Application for Licence Amendment

| Licence Number | L8422/2010/2 |
| Licence Holder | Edna May Operations Pty Ltd |
| Premises | Edna May Gold Project Warrachuppin Road WESTONIA WA 6423 Mining tenements: M77/88, M77/110, M77/124, G77/122 and L77/18 As defined by the Premises maps attached to the Revised Licence |

Figure 3: Piezometer location and seepage trenches

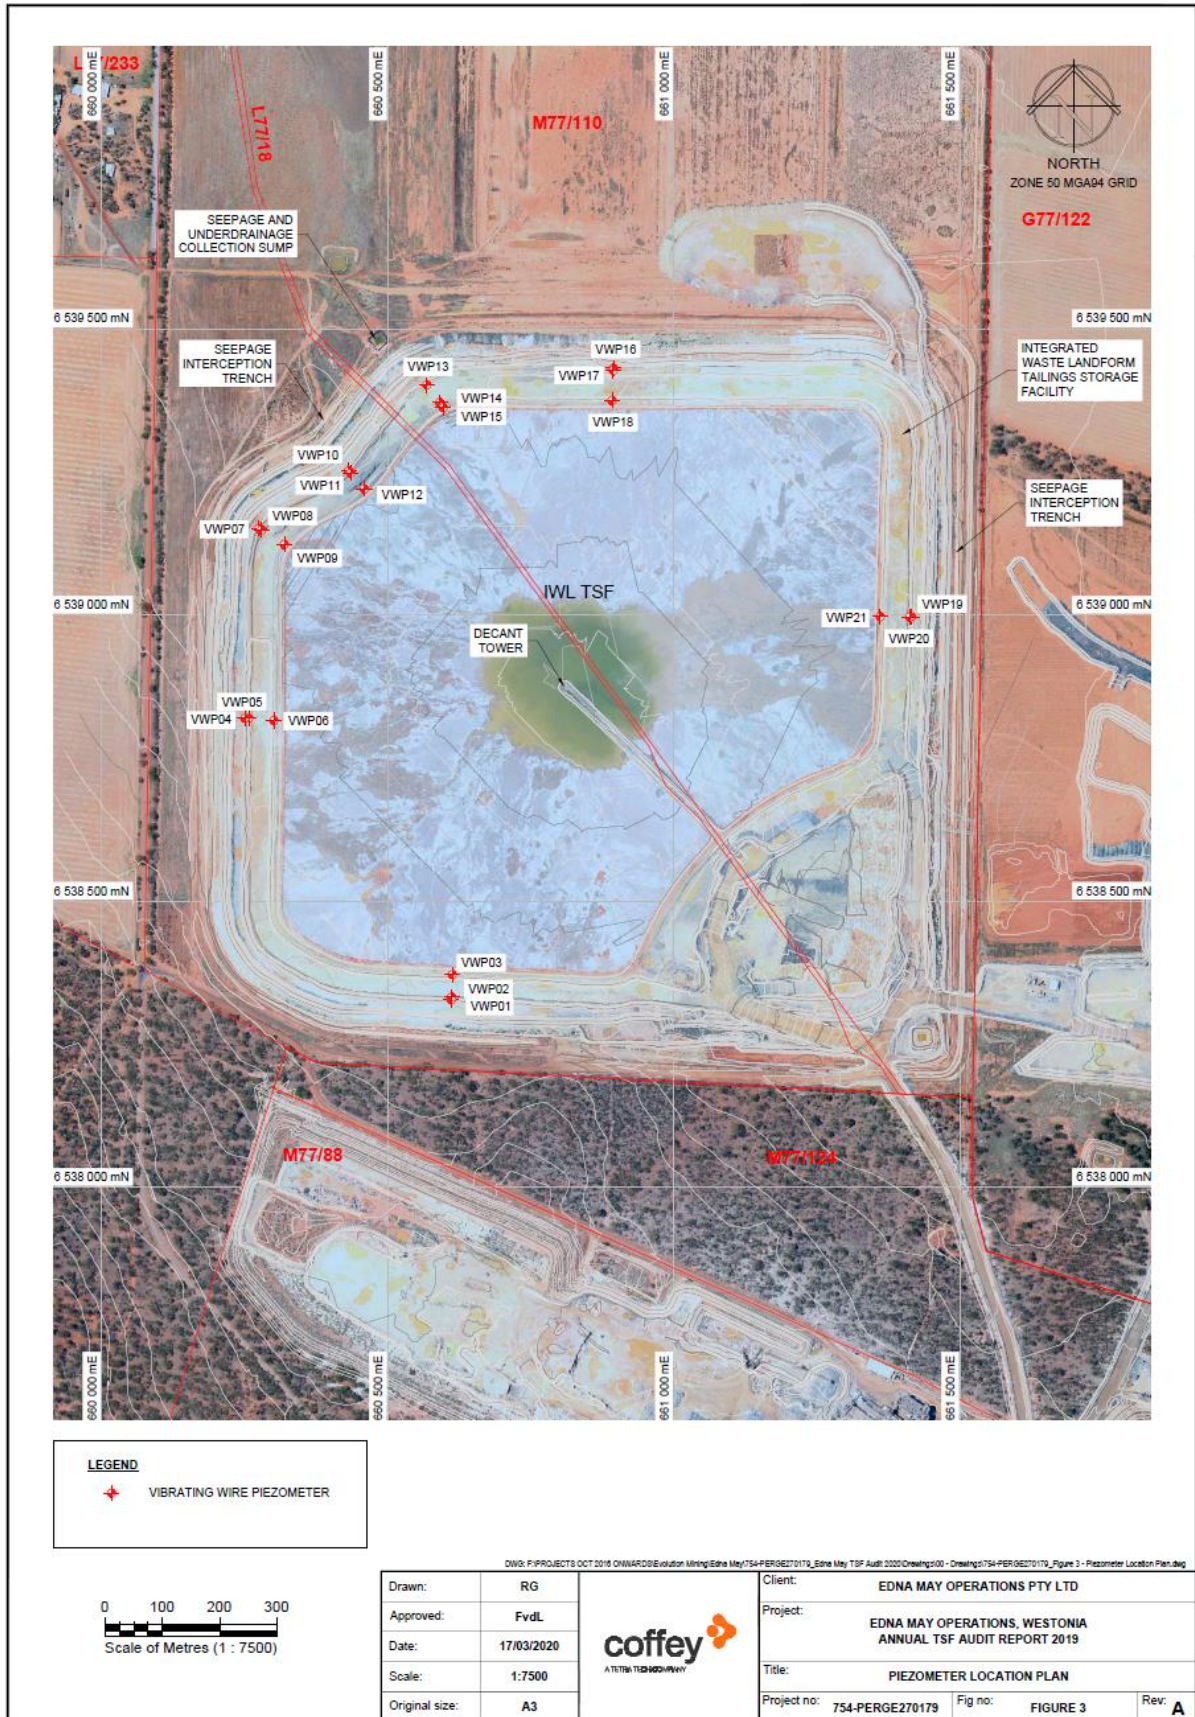
| Emission | Sources | Potential pathways | Proposed controls |
|----------|------------------------------|---|--|
| Tailings | Tailings from new ore source | Seepage of TSF | <p>The IWL has an underdrainage collection system and a seepage collection system.</p> <p>IWL has a compacted clay liner of approximately 1×10^{-8}m/s</p> <p>Perimeter seepage interception trenches and surface water diversion bunds are in place to mitigate potential impacts to nearby surface water receptors (see Figure 3).</p> |

Figure 7: Monitoring bore locations

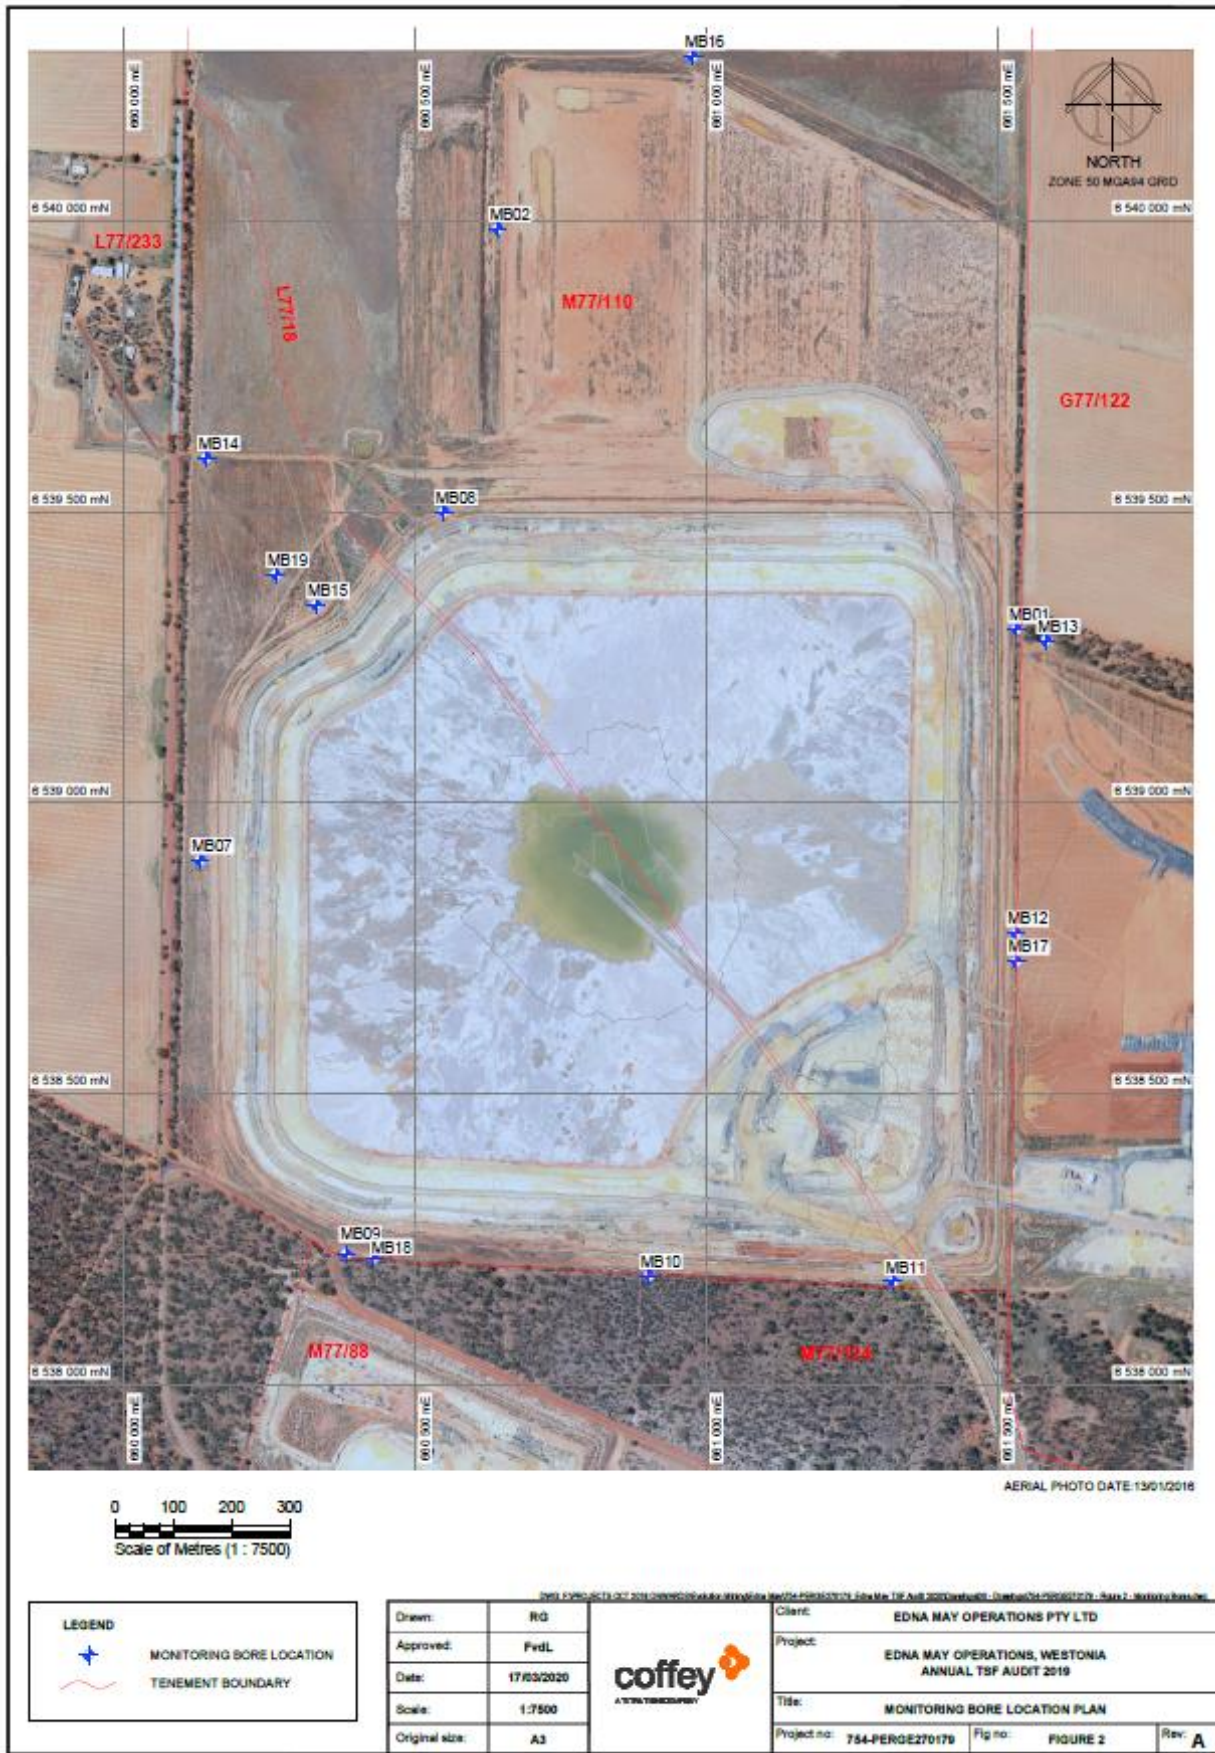
Groundwater monitoring around the existing TSF has indicated that there is significant seepage occurring from the eastern and north-western margins of the TSF on the basis of increasing metal and cyanide concentrations in some monitoring bores.

A water balance assessment that was undertaken by Rockwater consultants in 2018 suggests that currently the seepage rate from the TSF is about 1.9 mm/day. Additional information is required to understand the extent of the seepage, such as the distribution of the seepage from the TSF, the thickness and hydraulic properties of regolith materials that overlie the bedrock in the area, and the duration of the seepage as there is a risk that a groundwater mound beneath a TSF could increase in elevation and radial extent if allowed to continue for a prolonged period of time. Given that there is no increase in throughput associated with this amendment, it is recommended that further studies into seepage and site geology be undertaken at a later date.

The assessment of water level changes for the period of 2018-2019 by Coffey consultants suggest that groundwater mounding is relatively localised near the TSF. Water level data provided in a report prepared by Coffey consultants indicated that significant rises in the elevation of the groundwater potentiometric surface over this time period were only recorded in the following monitoring bores: MB13 (+1.07 metres), MB15 (+0.15 metres), MB7 (+0.07 metres) and MB19 (+0.10 metres). The most significant measured water level rise was near the north-eastern corner of the TSF (in bore MB13) (see Figure 7).

A groundwater level limit is included in the amended licence conditions for the TSF to ensure that management measures would be implemented to protect the health of vegetation if exceeded. The limit is that the depth of the groundwater potentiometric surface should be maintained at a depth of greater than three metres below the ground surface at each monitoring bore site.

Condition 16 and Table 5 has been updated - estimate of seepage loss has been added to the parameters of the water balance to determine the extent of the seepage of the TSF and monitor the potential contamination from the seepage.

Condition 17 and Table 6 has been updated - to include standing water level monitoring for every bore including a limit of 3m(BGL).
